**In the Drawings**

**REMARKS**

The office action mailed January 16, 2007 has been carefully considered. Within the office action, claims 29-32 have been rejected. In addition claims 1, 3, and 5-23 have been allowed. The applicants have amended claims 16-23, and 29-32. Reconsideration in view of the following remarks is respectfully requested.

FIG. 11

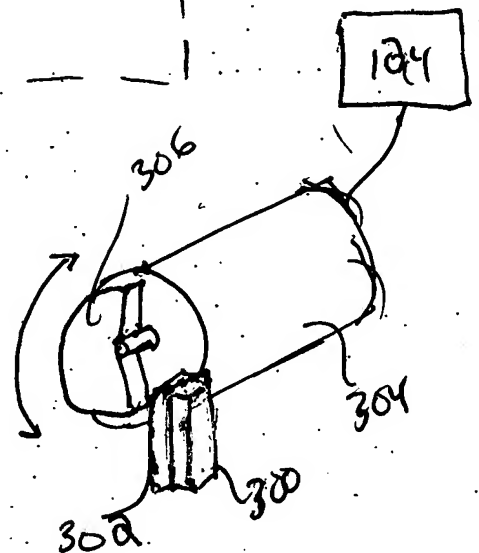
The drawing figures have been objected to in the Office Action. The applicants have added new figure 11 which illustrates an embodiment of the actuator including a spring member as well as an obstacle member. The drawing does not add any new matter considering that it is fully disclosed in paragraph 0039 in the applicants' specification. The applicants have also provided formal drawings for figures 1 to 11 which are included with this reply. Approval of the formal drawings is respectfully requested.

The attached replacement and annotated sheet(s) of drawings include the addition of Figure 11 which illustrates a rotary mass actuator including an obstacle as well as a compliant member. Figure 11 is completely supported by paragraph 0039 in the applicants' specification.
